SEATTLE ARENA

DOWNTOWN DESIGN REVIEW BOARD | RECOMMENDATION

PROJECT NUMBER: 301 4195 | 1700 FIRST AVENUE SOUTH

2.0 RESPONSE TO INITIAL RECOMMENDATIONS | 15

North Balcony Wrap Diagram

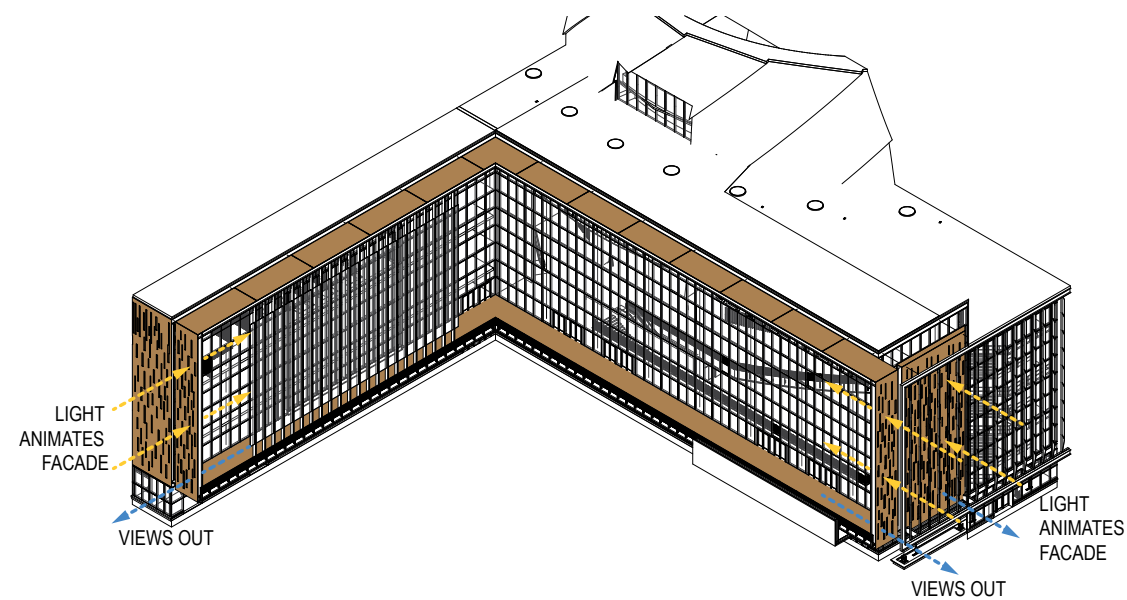
3) Strongly support the wrapping balcony and the plaza animation/overlooks it creates, but revise the solid vertical fins that 'capture' the ends of that balcony.(D-1, D-3)

Rendered View | North Elevation of Training Facility

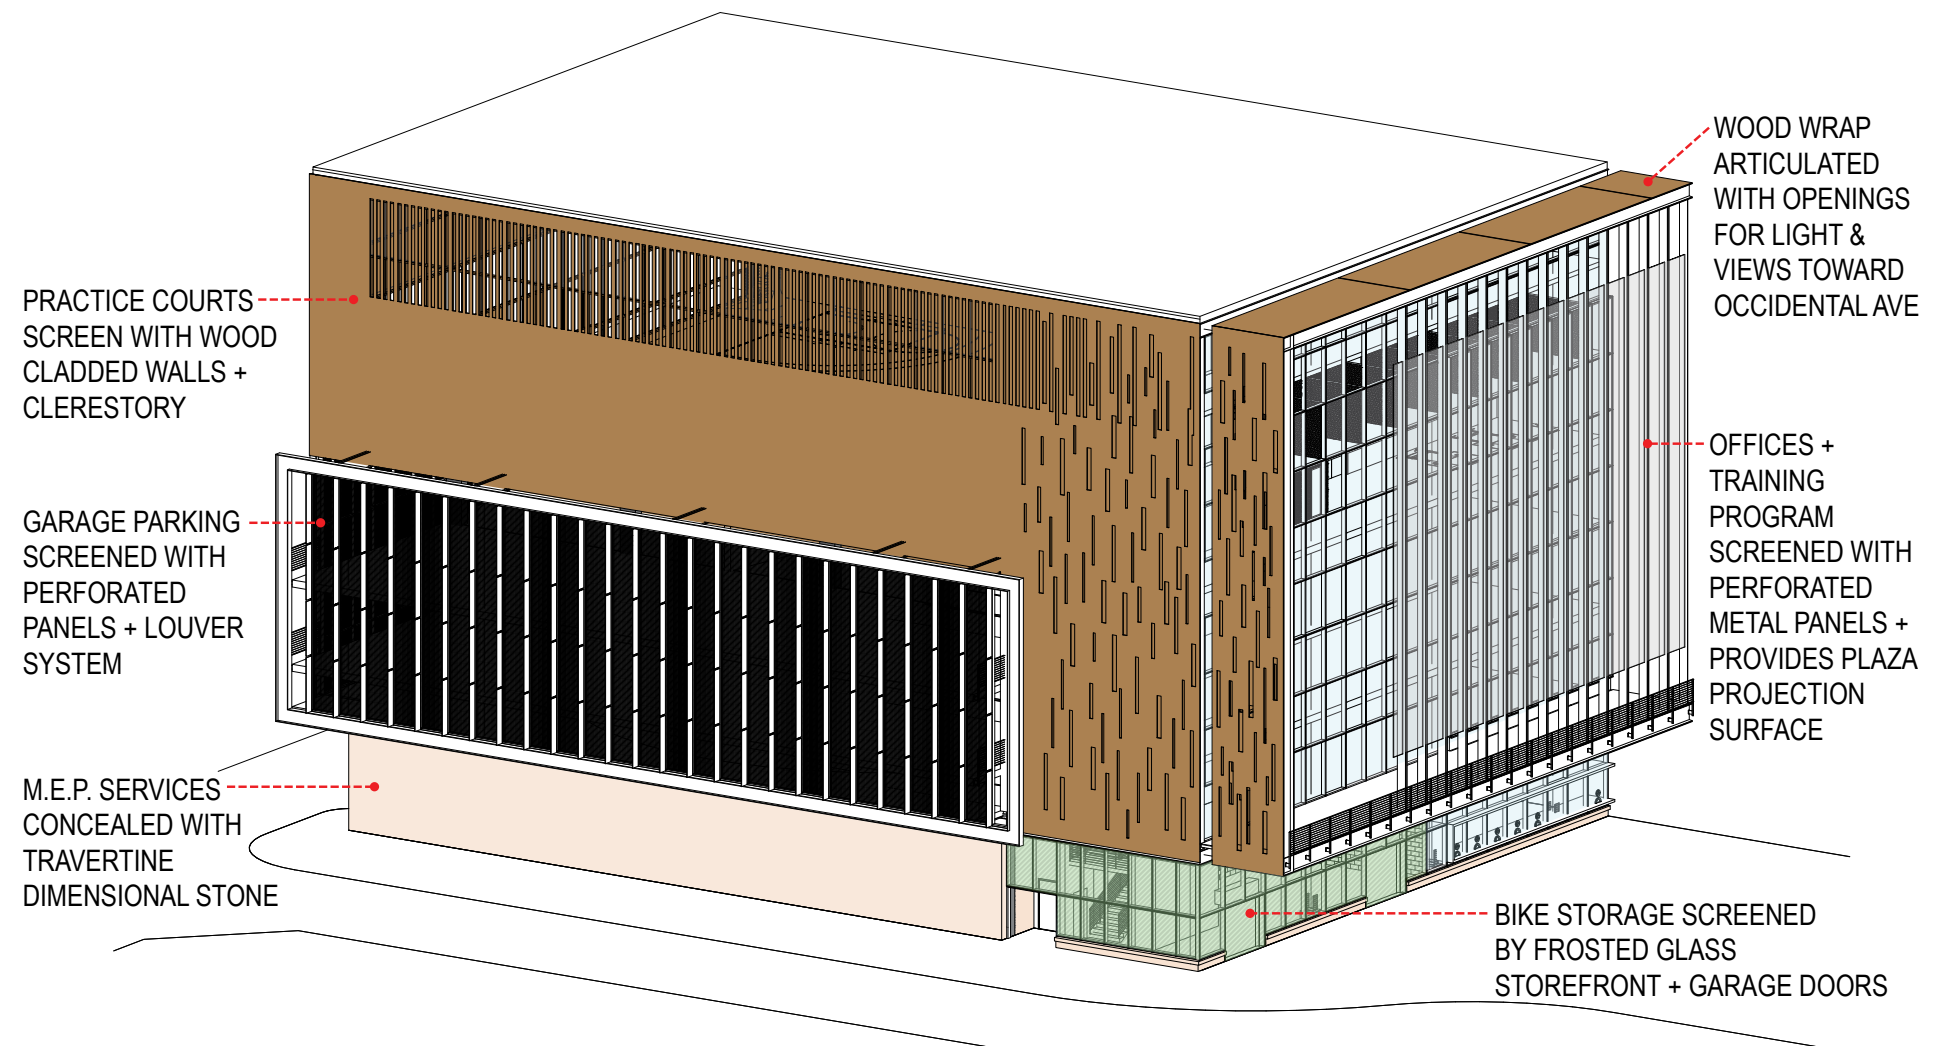
4) Add more scale and interest on the north practice wall, which is a highly visible terminus to Occidental Street and the adjacent Mariners plaza. [A-1, B-4, C-3]

The North façade of the training facility, once monolithic, has been revised to reflect the uses of the building: office, training facility and parking. This provides more interest to the terminus of Occidental.

SOLAR DIAGRAM

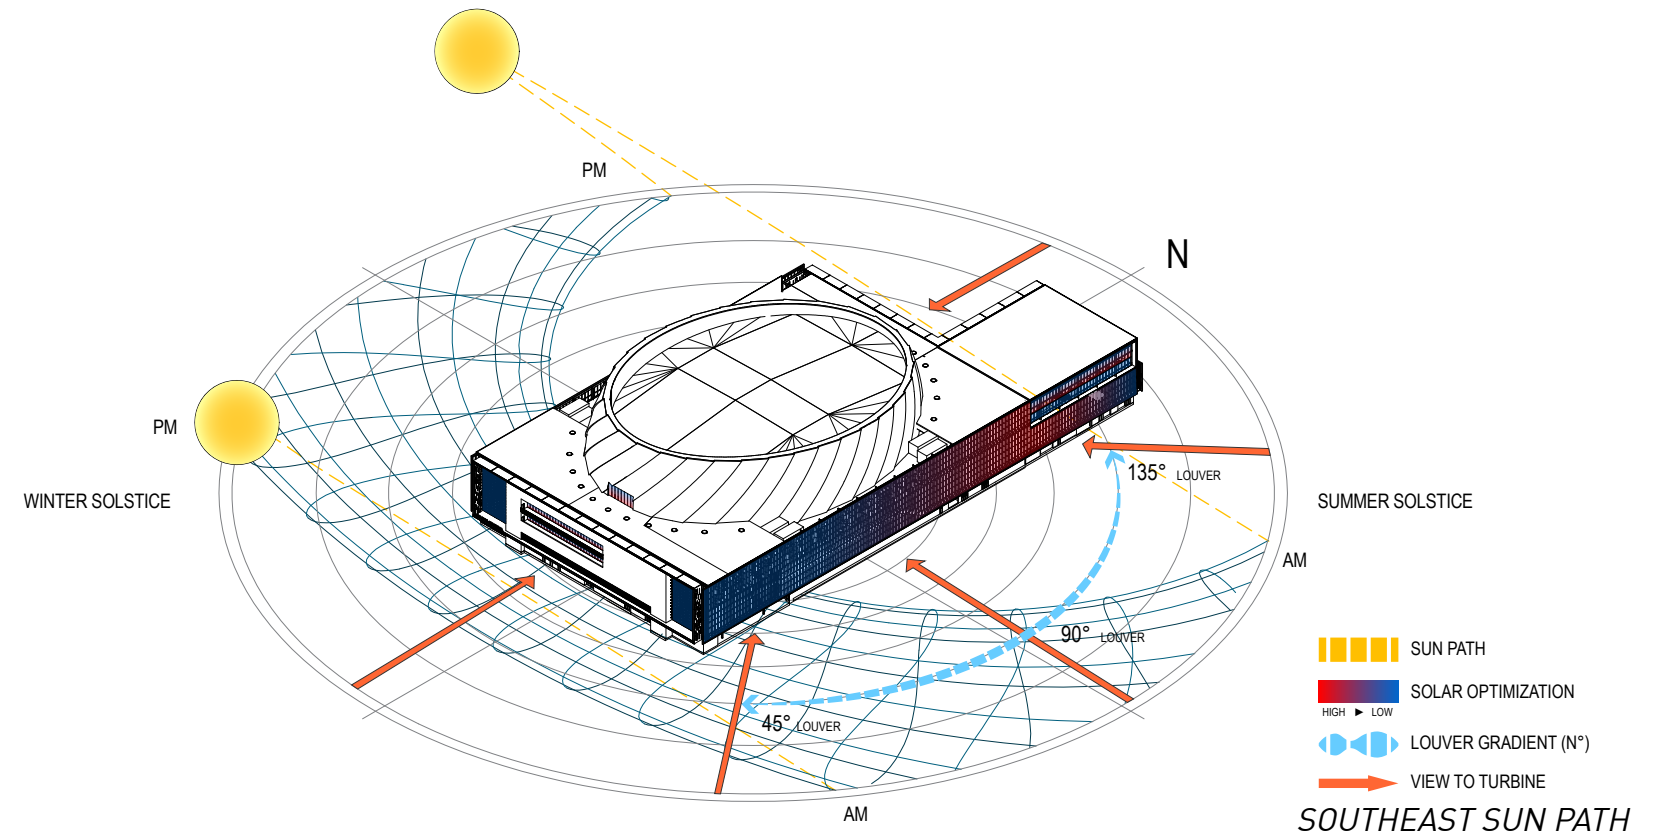
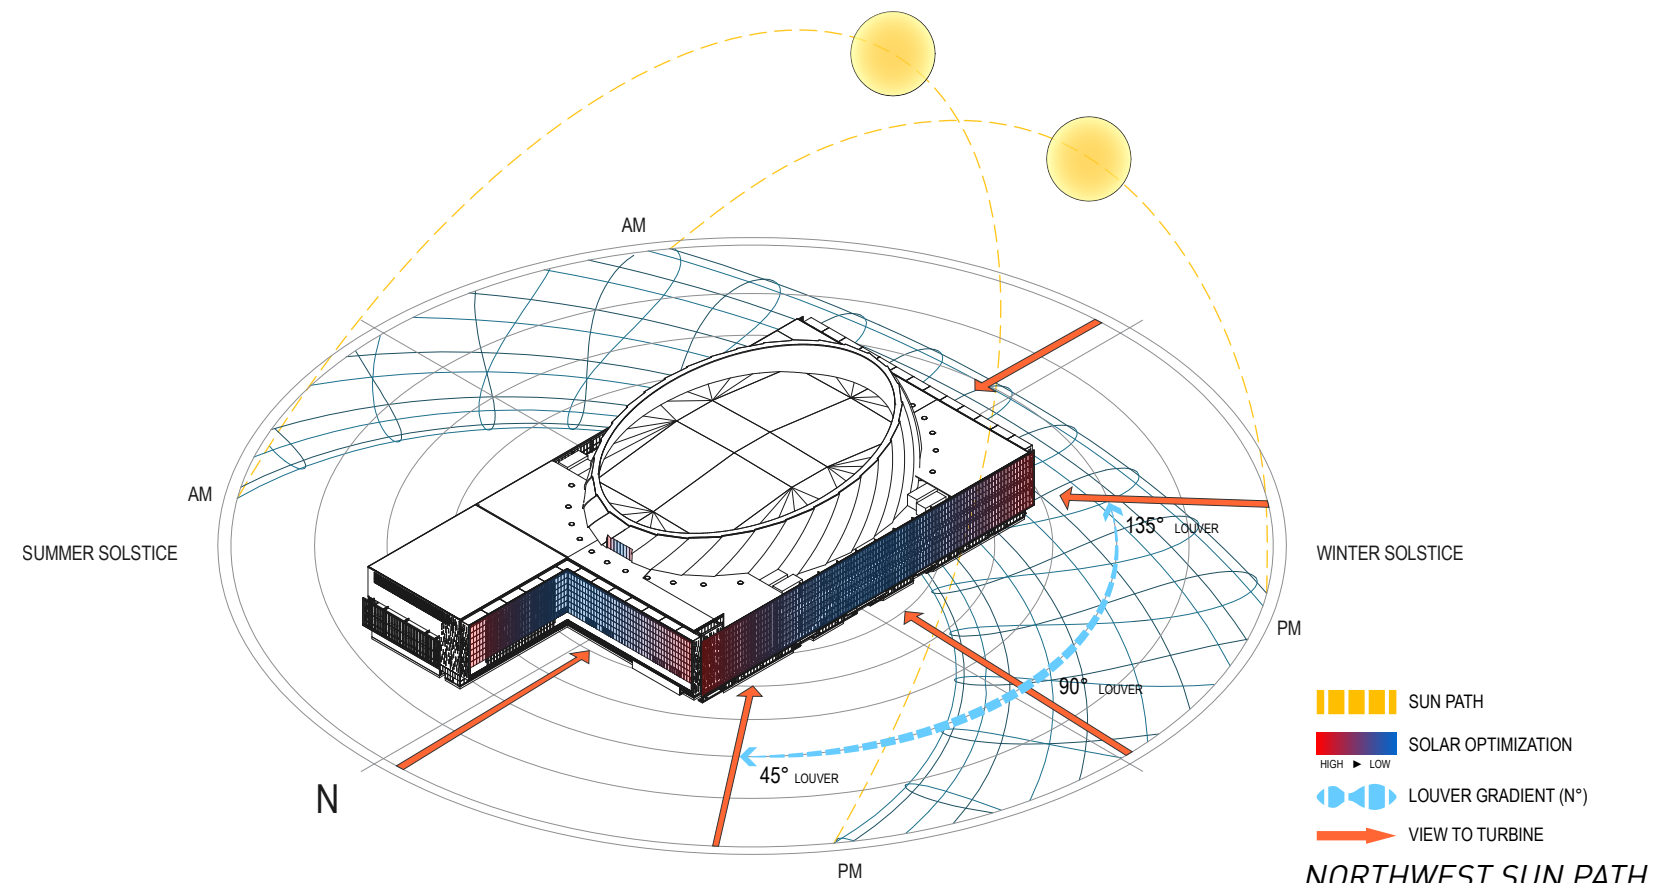
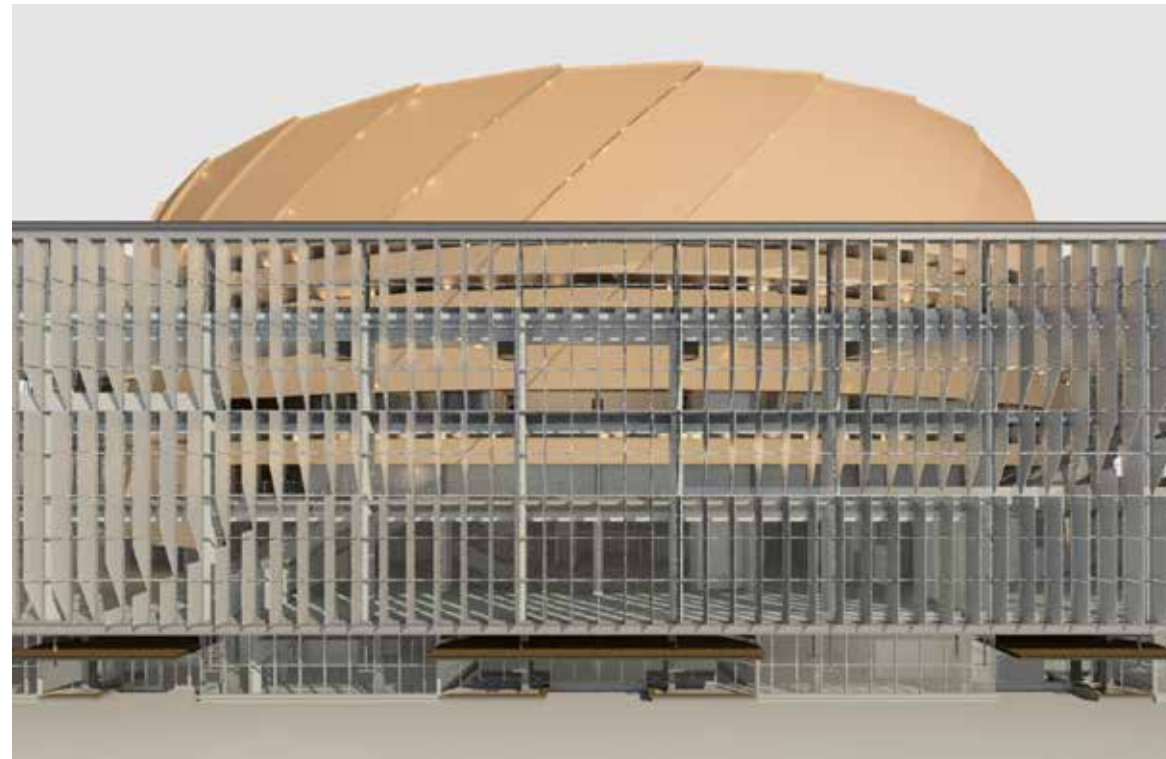
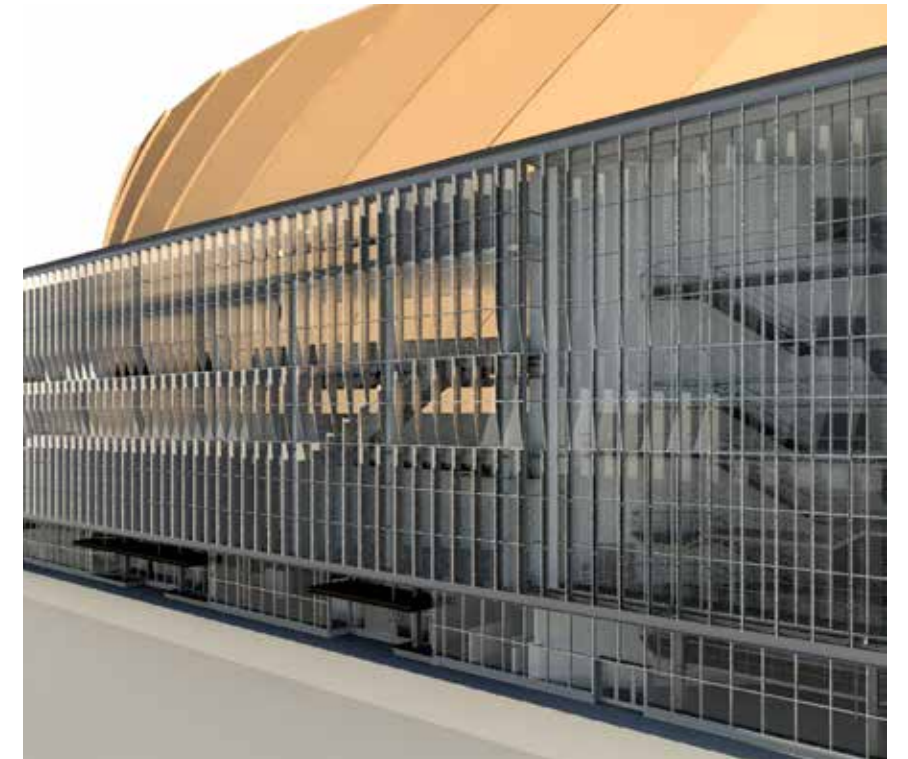
1) The brown louvers provide a positive mid-scale device for the whole building, but they should display more variation and transparency, in particular responding to the different context and climate conditions of the 3 orientations. The current louvers are overly uniform and evoke institutions rather than culture and entertainment.(B-1, C-2)

The louvers modulate to provide views in and out of the façade. Additional variation in the louvers have been added to adapt to signage and enhance views in and out of the façade giving the façade more “motion” analogous to the activities housed inside the facility.

PLAN AT CLUB LEVEL, FIRST AVENUE SIDE CLUB WITH OPTIONAL BALCONY

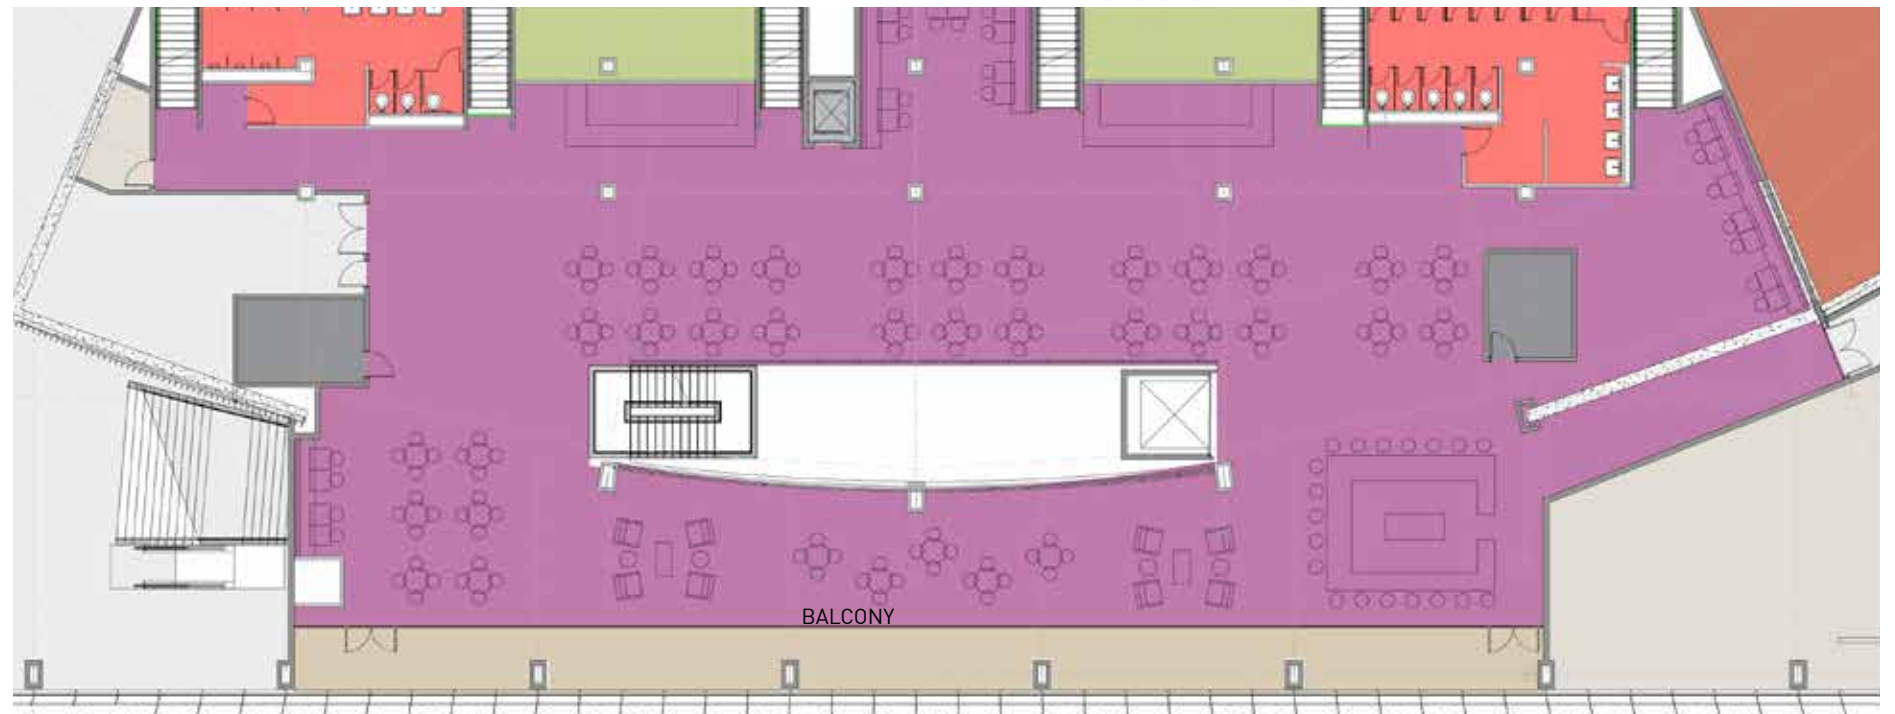
2) Maintain eye-level visibility out from the concourses, and consider adding balconies on the west wall over First Avenue, to break up the façade and provide exterior relief for patrons. The change in the wrapper façade treatment on Holgate was supported, including the balconies, material variation and horizontal shading, but more detailed information on the ground level uses and treatment are needed. More middle transparency is also needed, especially on the First Avenue corners and west wall, to ensure that the interior movement and energy is visible to pedestrians outside, on the streets and sidewalks. (B-3, C-1)
